In the following responses, reviewers' comments are reproduced in their entirety in black, and the authors' responses are noted in blue.

1. Research question on modeling impacts of tile drainage on hydrology and crop yield using ecosys model is new and worthy contribution to the literature.
2. Predicting crop yield using O2 modeling is novel
3. The manuscript could be significantly strengthened with additional details on the methods and a greater emphasis on novel results for the work.

Figure R1. Schematic of the processes in ecosys. Hydrological processes are highlighted with bold fonts (draft).

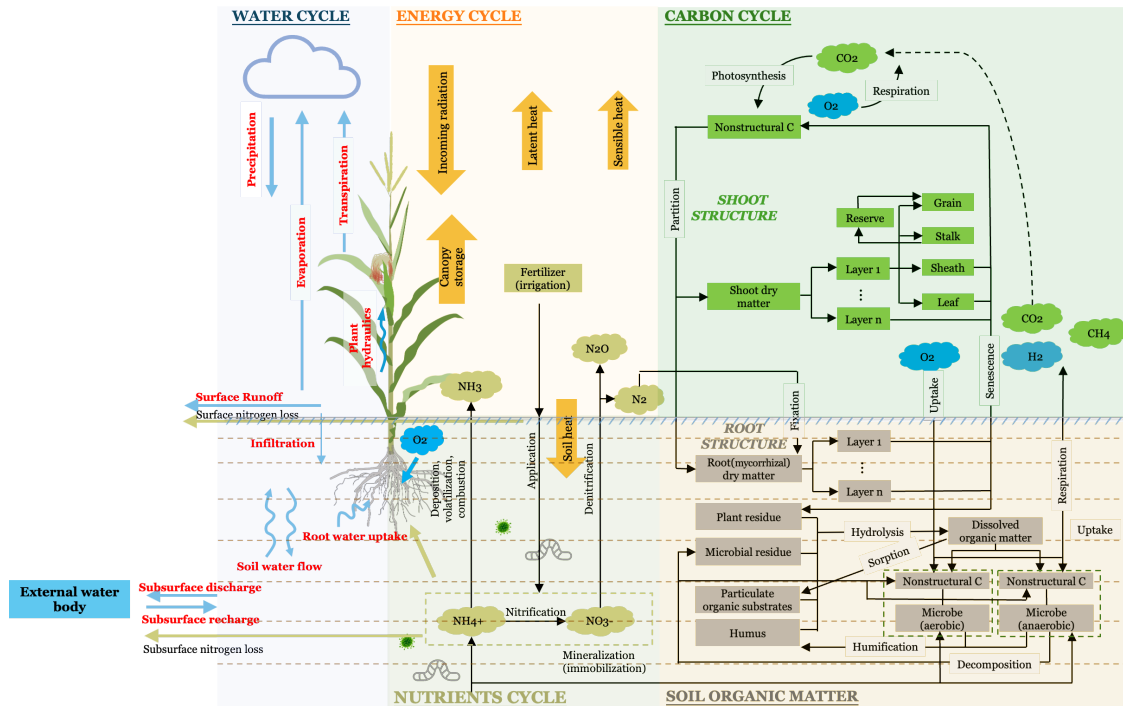
- Model setup:
 - o Hydrological processes lack clarity and better description of terms and more consistent useage of terms is needed: In Fig S1, terms used are surface leaching, runoff, infiltration, discharge, subsurface leaching. What is meant by surface/subsurface leaching?
 - o No subsurface recharge is shown in Fig S1, but it is discussed in results. What is this?
 - o "Subsurface discharge" used in results. Please define.
 - o "Subsurface recharge" used in results. Please define.

Response: Thanks for the comments and suggestions. In the revised paper, we will revise Figure S1 to make sure those concepts are well defined (Figure R1).

In *ecosys*, the water exchange between the simulated field and the surrounding environment is conceptualized as water exchange between the field and an external water body, which defines the subsurface boundary conditions with a specific external water table depth and lateral distance to the external water table. Subsurface discharge refers to the below-ground water flux that leaves the field to the external water body, which happens when the field water table is higher than the external water table. Subsurface recharge refers to the below-ground water flux that enters the field from the external water body, which happens when the field water table is below the external water table. We will use surface runoff to refer to the water fluxes leaving the system on the surface. Infiltration refers to the water flux from the surface to the subsurface. We will use surface nitrogen loss and subsurface loss to replace surface leaching and subsurface leaching to represent nitrogen loss through surface and subsurface loss paths.

Figure R2. Tile fractions over the U.S. Midwest region, and the location and layout of the selected experiment field. Yellow boxes represent sub-fields without tile drainage, and green boxes represent sub-fields with conventional drainage.

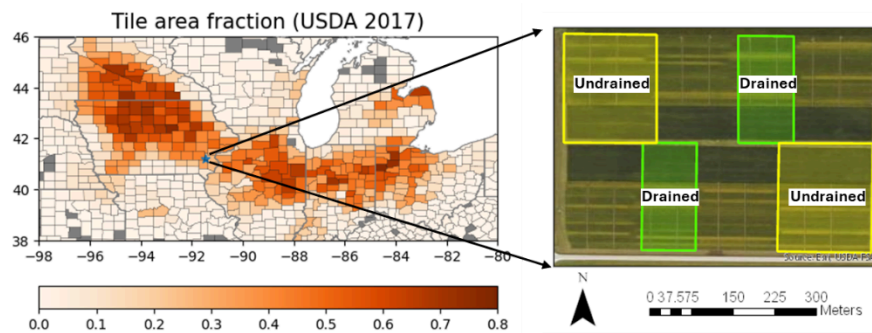
- What is the scale of the model, and what are the boundaries of the setup?

21. Line 288, this figure (Fig S5) should be improved and placed in the main paper. There is no scale or dimensions and the text in the figure is not very clear. As this is key to the calibration & validation, it should be described more clearly.

Response: Thanks for the comment here and the details in the supplement materials. In the revised manuscript, we will specify that *ecosys* is a 3D ecosystem model. This paper performs a diagnostic analysis at an experimental site in the Iowa State University Southeast Research and Demonstration Farm in Washington County. Accordingly, we have revised Figure S5 to show the geological information of the experiment site as follows:

Response: We will revise Figure S5 (see above responses) to show the geological information of the experiment site.

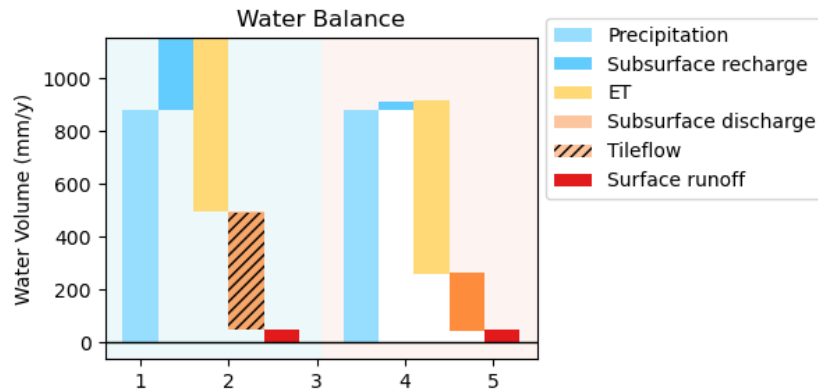
- Why is precipitation different in tile vs no-tile treatments (Fig. 6)?

3. Fig 6 - keep tile drainage volume separate.

4. Fig 6 - Is subsurface recharge (“water going into the field”) flow from adjacent fields? Please define this parameter?

Response: Sorry for the confusion. The precipitation under tile and no tile conditions is the same. We will update the figure (Figure R3). Note, tile flow is a type of subsurface discharge.

Response: Thanks for the comments. We will update Figure 6 in the revised paper.

Response: Sorry for the confusion. As shown in Figure S21, the amount of precipitation is smaller than the sum of the field evapotranspiration and tile flow, and additional water fluxes from the surrounding environment, including the adjacent field, are required. In the *ecosys* model, the surrounding environment is conceptualized as an external water table, and subsurface recharge is defined as the water flux from the external water table to the field through subsurface paths. The external water table is characterized by a specific external water table depth and lateral distance to the external water table. We will clearly define it and revise Figure 3 accordingly.

Figure R4. Example of precipitation inputs in the numerical experiments. Basically, we changed the precipitation on each time step with a scaling factor (i.e., 0.9, 1, 1.1, 1.2, and 1.3) to account for the increased rainfall amount.

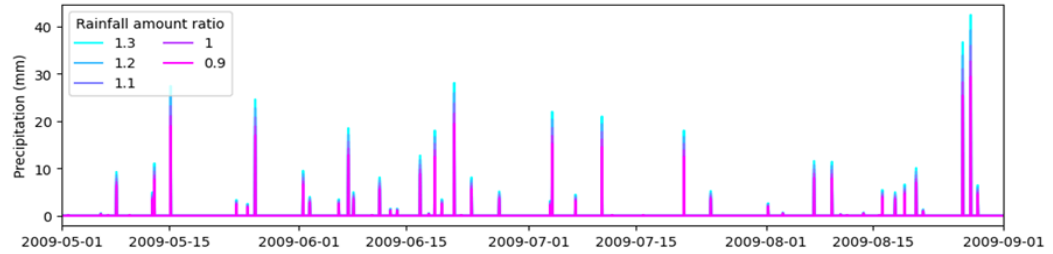
- o How was additional precipitation distributed? The seasonal/daily/hourly distribution of rainfall is important. Please comment on this.

Response: Thanks for the comment. We acknowledge that the way additional rainfall is apportioned across seasons, days, or hours can strongly influence flood dynamics and, consequently, crop responses. In our experiments, we did not alter the seasonality or the intra-daily/hourly structure of precipitation; instead, we applied a uniform scaling factor to each time step of the original precipitation record so that the total seasonal (or annual) rainfall increases by the specified amount, while the relative variability at all timescales is preserved, as shown in Figure S7. We will make it clearer in the revised paper. Though the extreme rainfall might happen more frequently in the future, there is no standard way to distribute additional precipitation, and the uncertainty in distributing additional precipitation might outweigh the signal we aim to study.

Figure R6. Precipitation and ecosys simulated runoff time series. a) The time of precipitation. b) the time series of the runoff.

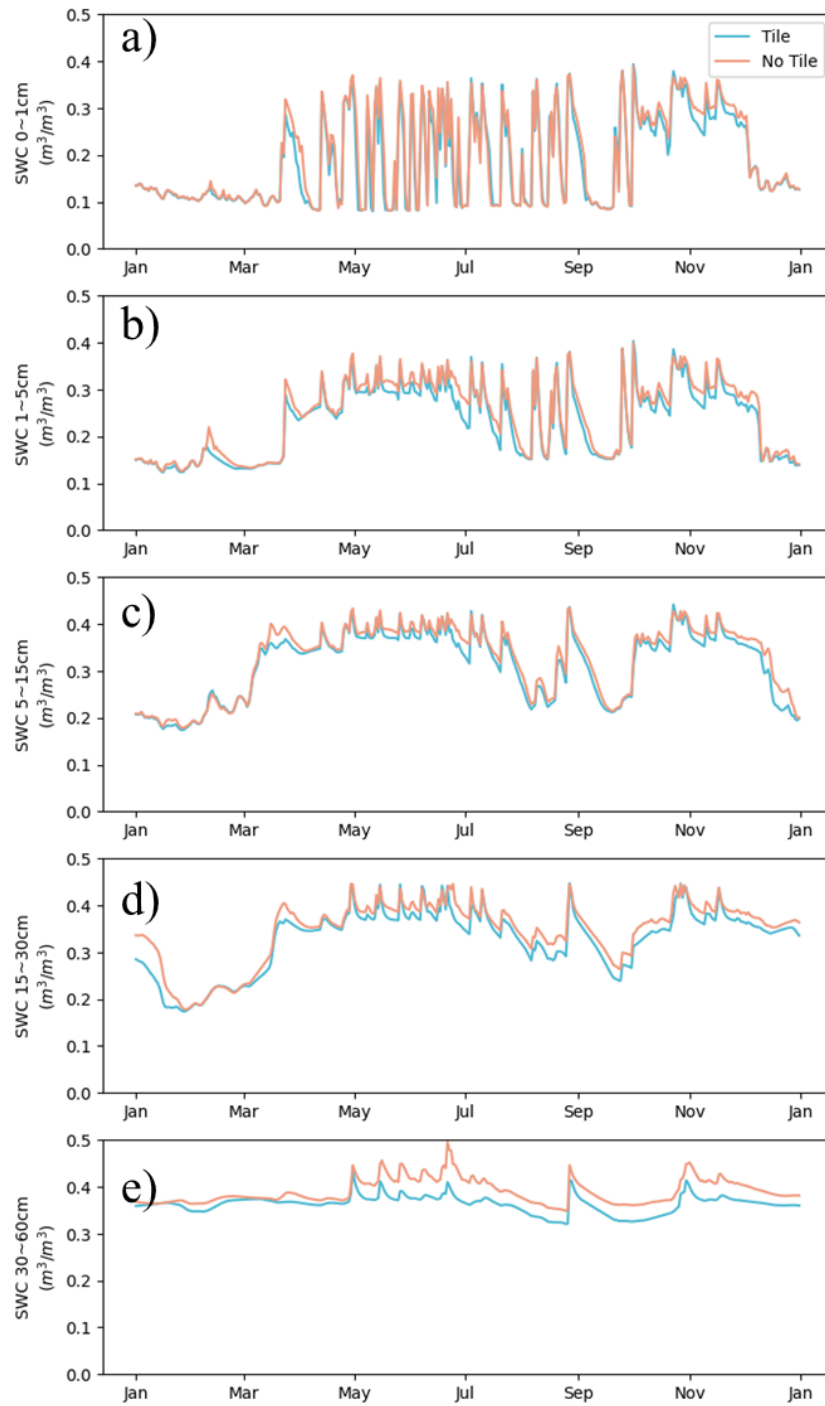
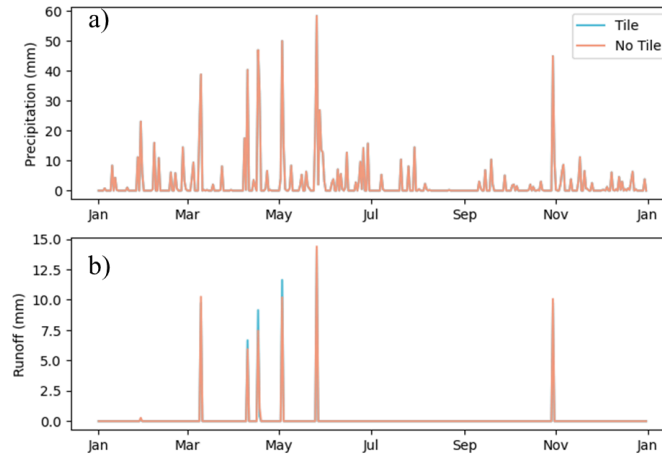
1. Predicted *no impact* or *increase* of surface runoff in the tiled scenario (Fig S10 and line 385)—what is the explanation for this unusual result (normally, surface runoff decreases with tile drainage)?

Response: Thank you for your comments. We have analyzed the model setups and identified factors influencing the simulated runoff. The surface runoff primarily occurs during significant rainfall events, indicating that the infiltration-excessive mechanism dominates surface generation (Figure R6). The model estimates the infiltration rate based on soil water content, as shown in Figure R7 across different soil layers. While tile drainage generally lowers soil water content, its impact is more significant in deeper soil layers. Our simplified 1-D column representation of the field reduced surface water holding capacity, diminishing the role of tile drainage in managing surface water. This rapid removal of surface water likely underestimates tile drainage's influence on surface runoff regulation, potentially explaining the lack of impact in the scenario. Upon reviewing the model's internal processes, we identified potential numerical issues. Initially, drier soil conditions under tile drainage led to substantial infiltration fluxes, saturating the topsoil. Once saturated, infiltration decreased to zero, resulting in a slight overestimation of surface runoff. In the revised manuscript, we will further elaborate on the simplification that underestimates tile drainage's role in surface runoff estimation and address the identified numerical issues.

Figure R7. Ecosys-simulated soil profile of a typical dry soybean year. The profile of a) Soil water content, b) soil oxygen concentration, and c) root density in the soil column on June 17th, 2013.

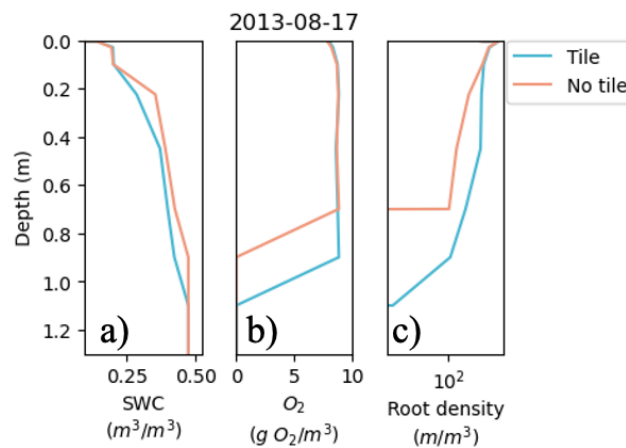
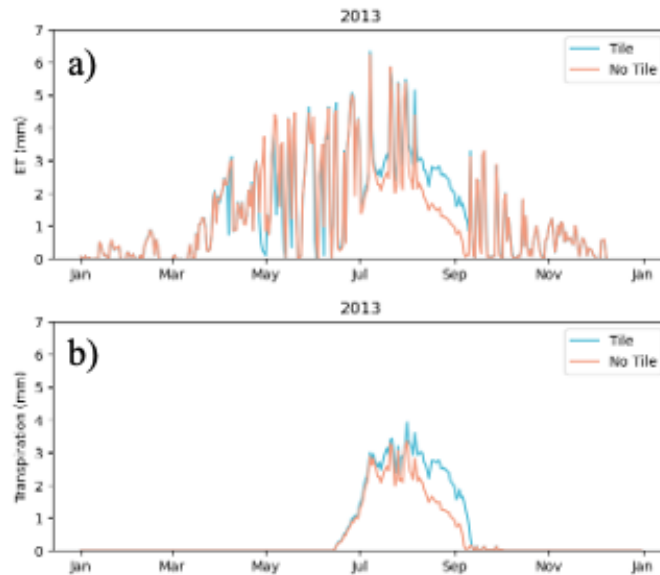
2. What is the mechanism for tile drainage increasing ET in the summer months?

Response: We hypothesized that tile drainage increases ET in the summer months through promoting crop transpiration via stronger roots developed in the early growing season. Figure R7 shows the modeled profile of soil water, soil oxygen concentration, and root density on August 17th, 2013 (a dry summer). The results indicate that tile drainage reduces soil water content while promoting root growth. Though the reduced soil water content might expose the crop more to water stress, the developed root offsets the water stress induced by reduced soil water content in our case, which ultimately increases crop evaporation (Figure R8).
